Summerlin West Village 22-Kettle Ridge Drive
(Sheet J)

CITY OF LAS VEGAS INTER-OFFICE MEMORANDUM			DATE: January 21, 2021
TO: Land Development Services Department of Building & Safety			FROM: Albert Sung, P.E. Flood Control Project Engineer Department of Public Works
SUBJECT: Drainage Study for: Summerlin West Village 22 - Kettle Ridge Drive (Street J) (from Sunset Run Drive to Kindle Rise Way)			COPIES TO: Atkins Global
Cross Streets:	Kettle Ridge Drive and Sunset Run Drive		Howard Hughes Company, LLC.
File Number:	F:\Depot\DSMemos\DS5349C.doc		Bart Anderson, P.E., DevCo
Parcel Number:	137-23-210-001		CCRFC
Zoning Action:	N/A		
FEMA Flood Zone	YES	NO X	
Proposed Storm Drain	YES X	NO

Supplement to Addendum #1

RE: Supplement to Addendum 1 to the Technical Drainage Study for Summerlin West Village 22 Kettle Ridge Drive: Sunset Run Drive to Kindle Rise Way

"KRD" STA. 43+53 SEE SHEET 15

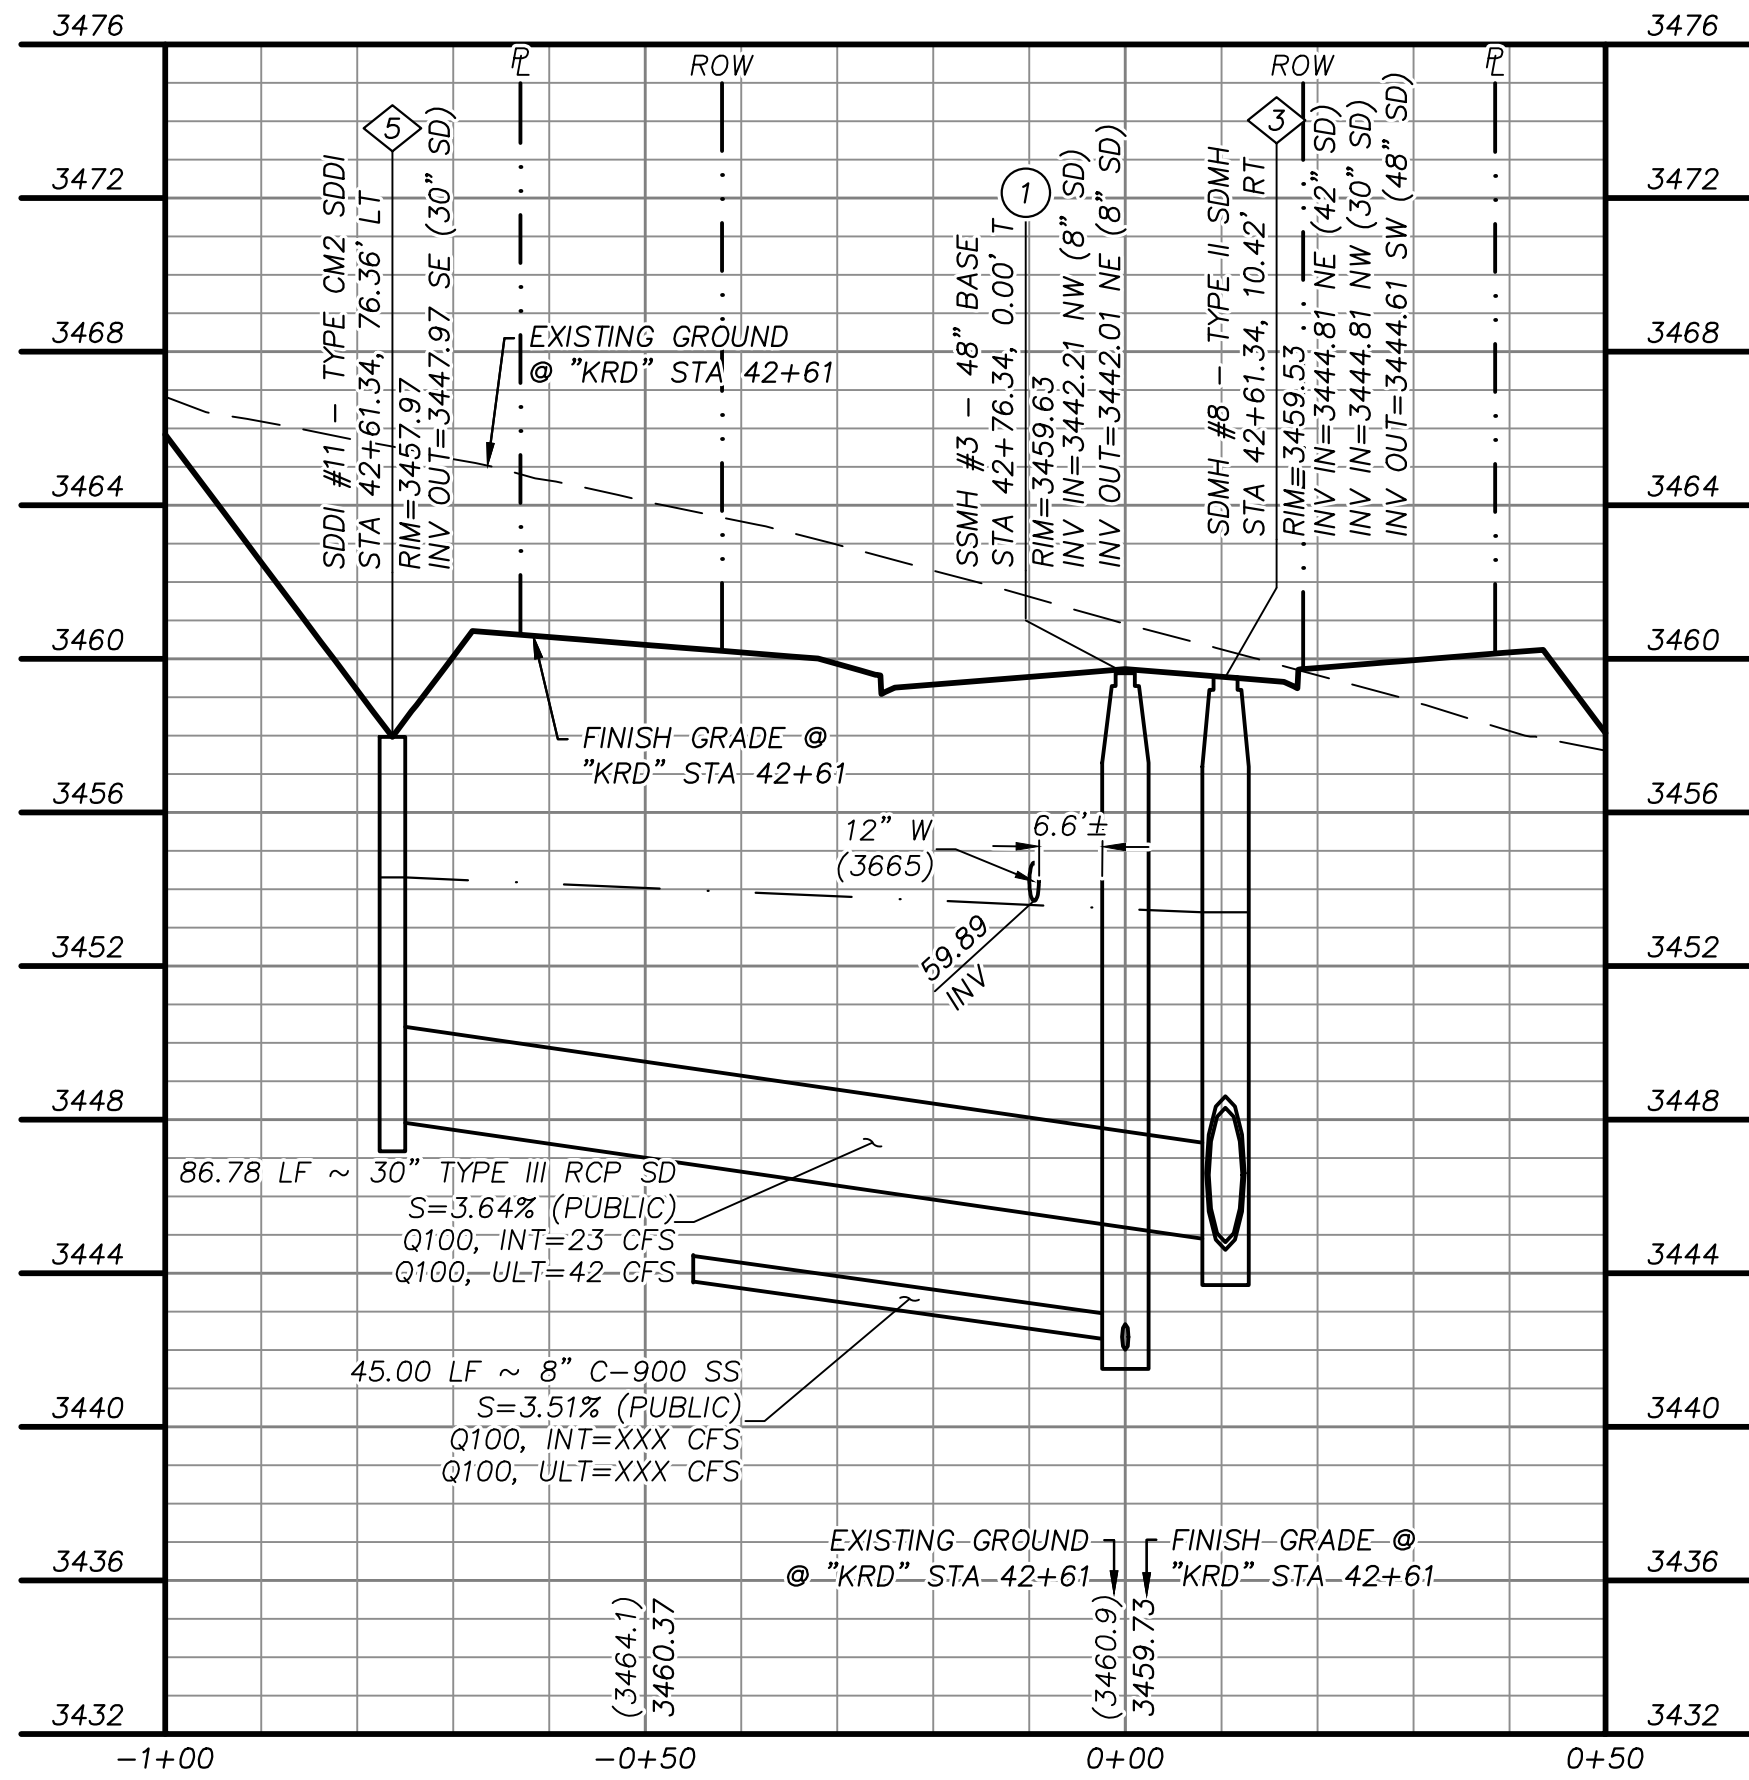
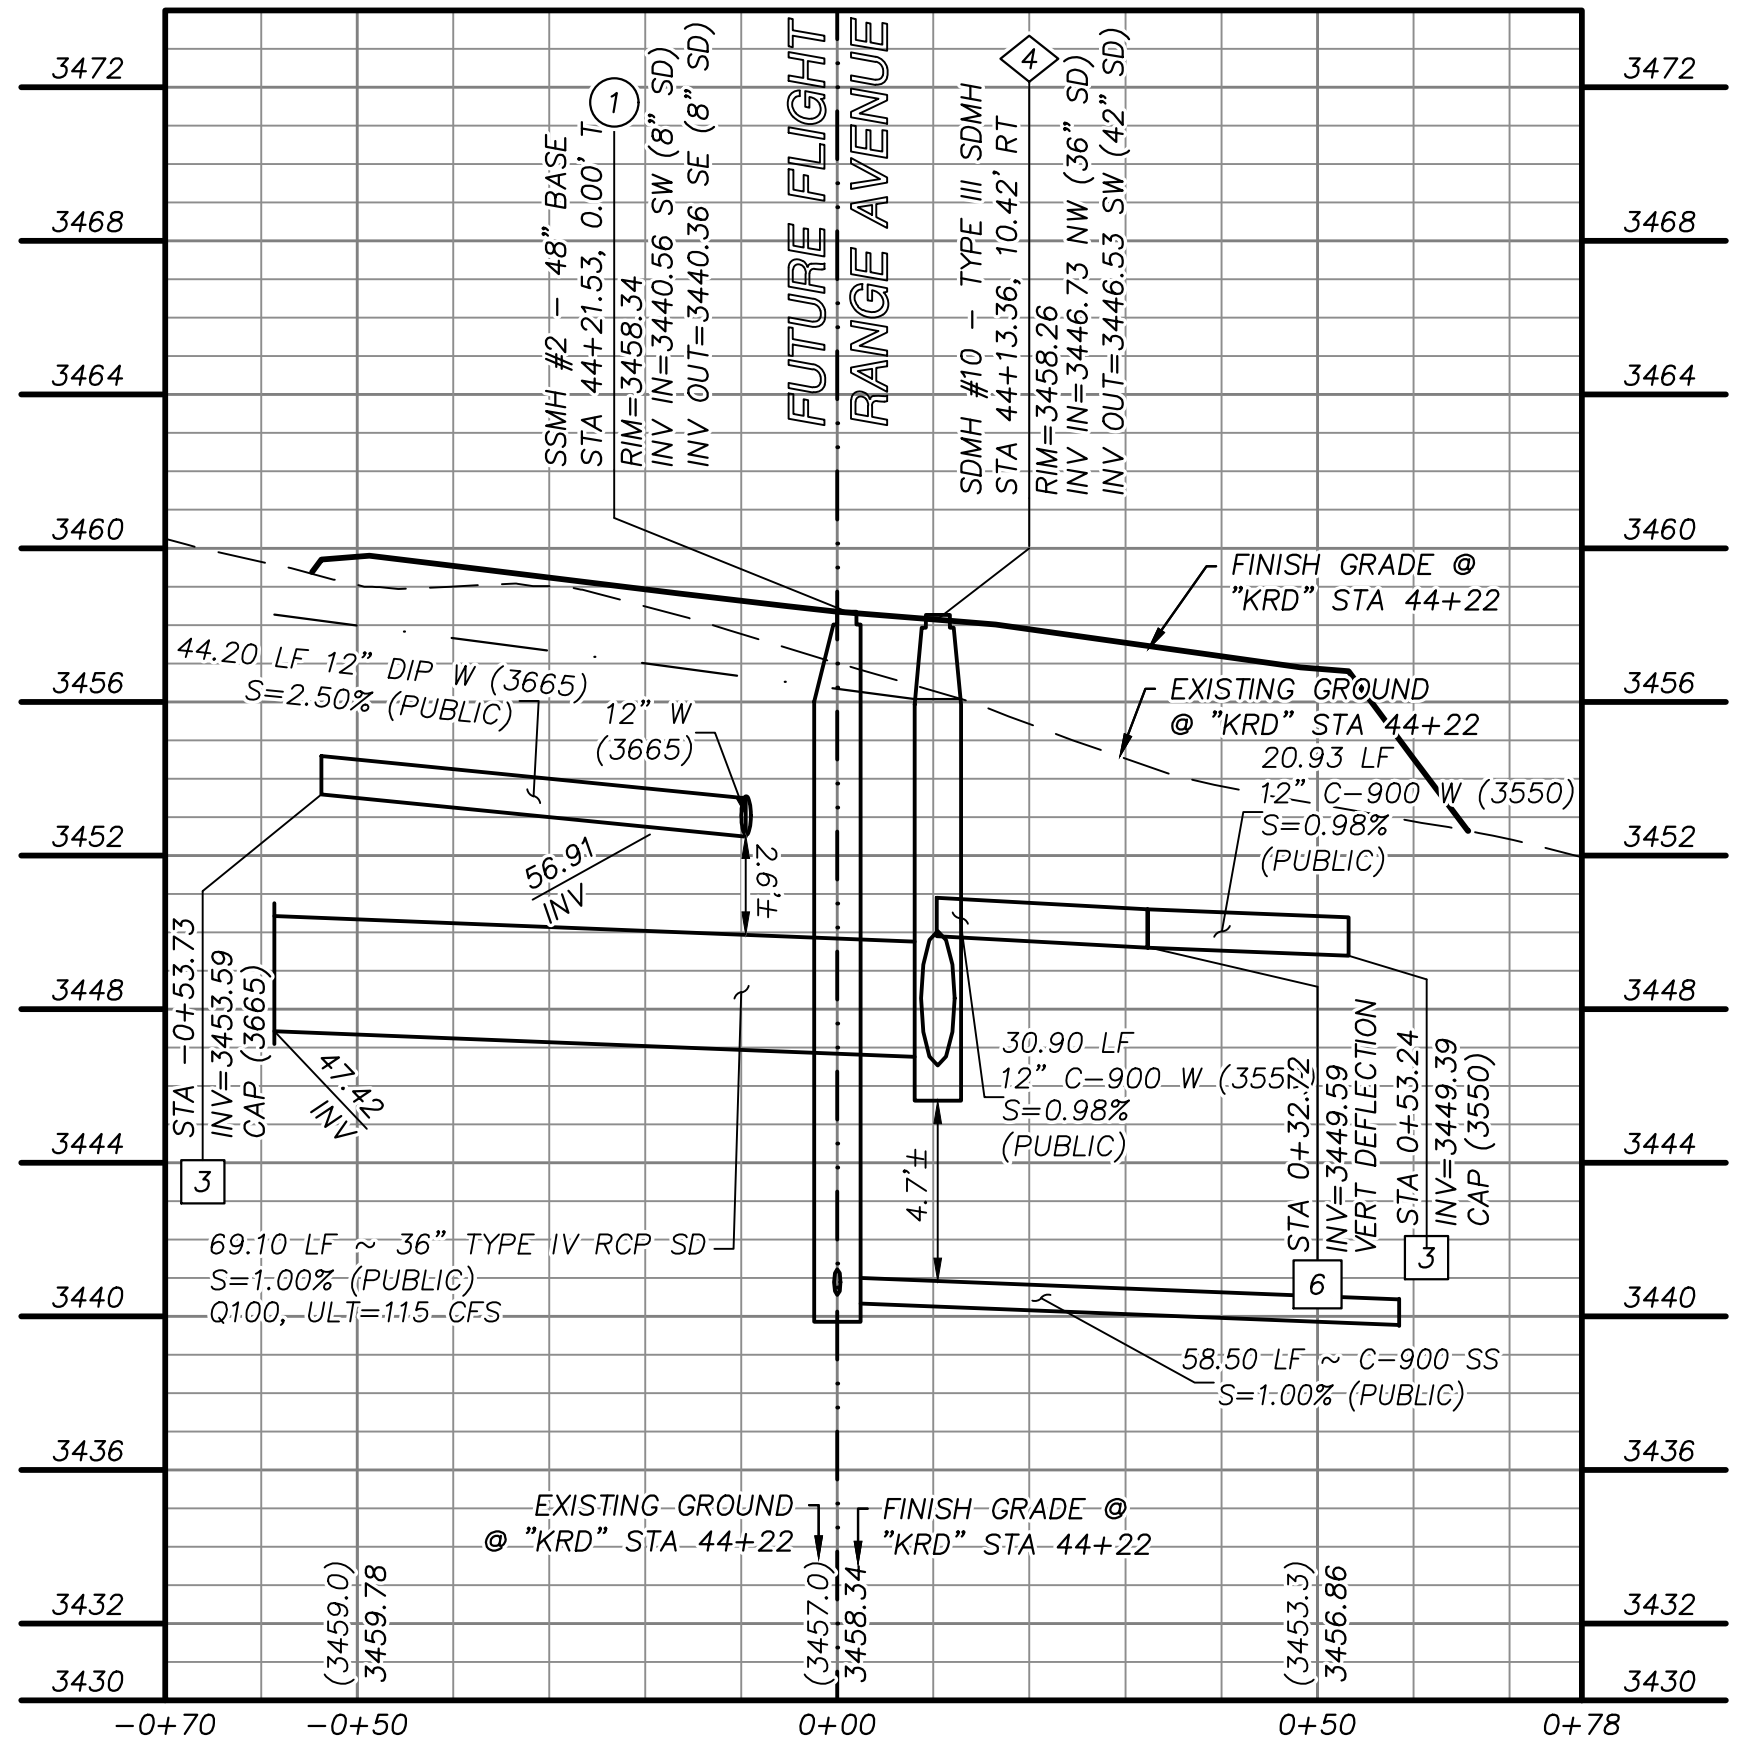
Comment #6: Previous Comment: Sheet 20/26 & Sheet 21/26: In general, the HGL shown on the profiles for the laterals do not match the calculations. For example: The HGL is lower than the base of the inlet for SDDI #10.

6. **Previous Comment: Sheet 20/26 & Sheet 21/26: In general, the HGL shown on the profiles for the laterals do not match the calculations. For example: SDDI #2: Calculation shows a lower water surface while the profile shows a much higher water surface. SDDI #5: The HGL is even lower than the base of the inlet. Same for SDDI #10.**

The response to SDDI #10 is still un-satisfactory: The HGL is still lower than the base of the inlet. Perform better quality control in the next submittal.

Comment response: SDDI #10 lateral has been revised to show the correct HGL. The associated WSPG-W output is included for review convenience.
